Nanga Road, Waroona WA

Road Improvements between Slk 0.37 – 2.02.

Road Safety Audit

Stage 3 - Detailed Design

Finding 2.1 Non frangible trees close to the traffic lane, a hazard to an errant vehicle.

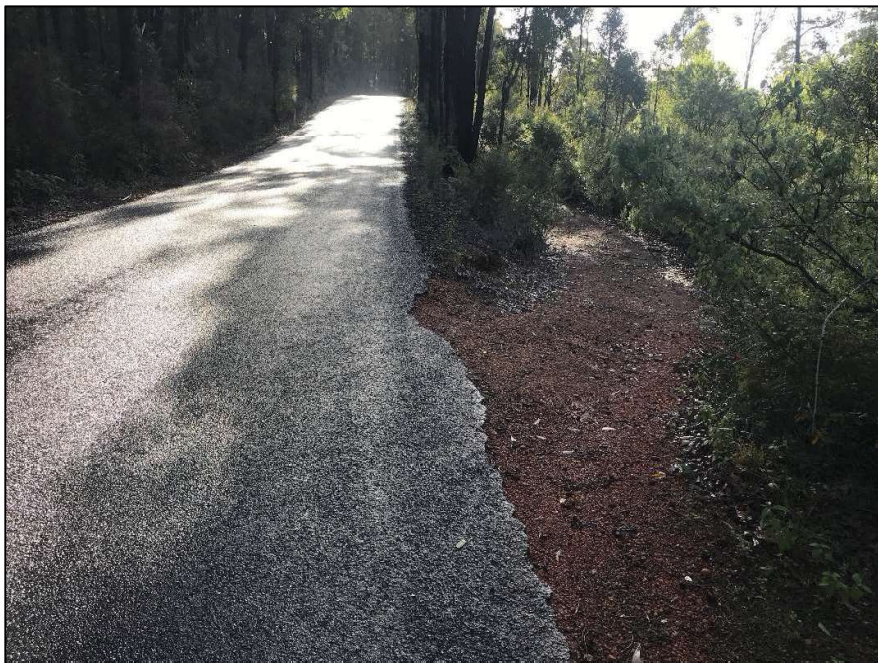
Large trees are close to the traffic lane.

There are large trees located on the verge, close to the traffic lane that pose a risk to vehicle occupants in the event an errant vehicle leaves the road, particularly those on the outside of curves.

Finding 2.1 Non frangible trees close to the traffic lane, a hazard to an errant vehicle.

Determine the Network Roadside Risk Intervention Threshold for the road. If the action is to treat only the isolated hazards, then those that present a higher risk should be treated first. These will be the isolated hazards that are closer to the road.

Alternatively, use the Austroads: Guide to Road Design Part 6 - Roadside Design Safety and Barriers (2010) Table 4.1: Clear zone distances from the edge of through travelled way and provide a suitable clear zone.

Finding 2.2 – – Insufficient sight distance from the side-track. Consider closing the access to the road.

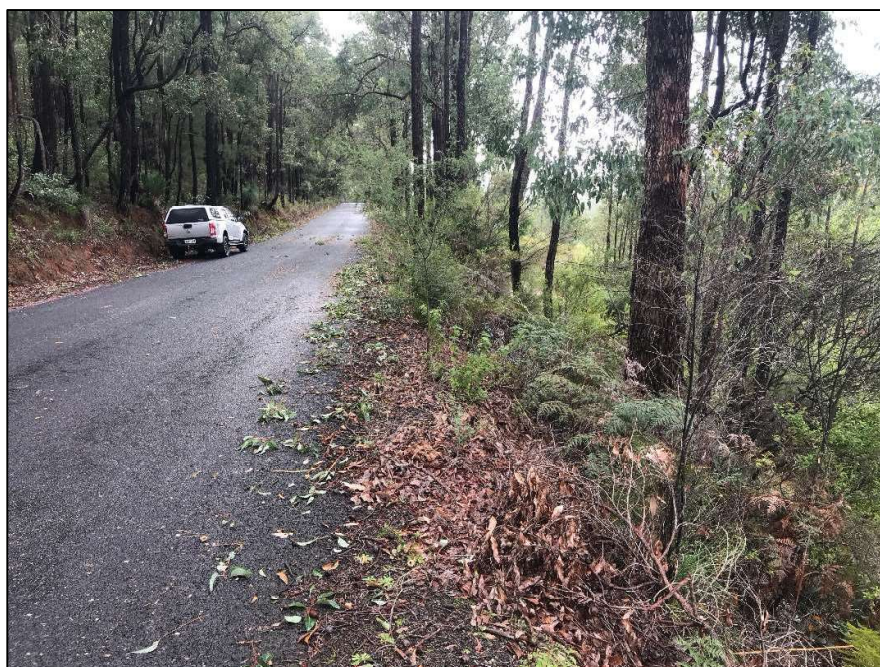
There are several camping areas and small side-tracks with restricted sightlines due to vegetation.

The limited sight distance can result in restart intersection crashes where the driver stops at the intersection, then restarts resulting in a crash. Restart crashes can be the result of insufficient Safe Intersection Sight Distance (SISD), drivers pulling out in front of an approaching vehicle, hidden by vegetation resulting in a right-angle crash.

Finding 2.2 – Insufficient sight distance from the side-track. Consider closing the access to the road.

Clear the vegetation to provide Safe Intersection Sight Distance at the intersection locations.

Remove access from tracks where access is unsuitable.
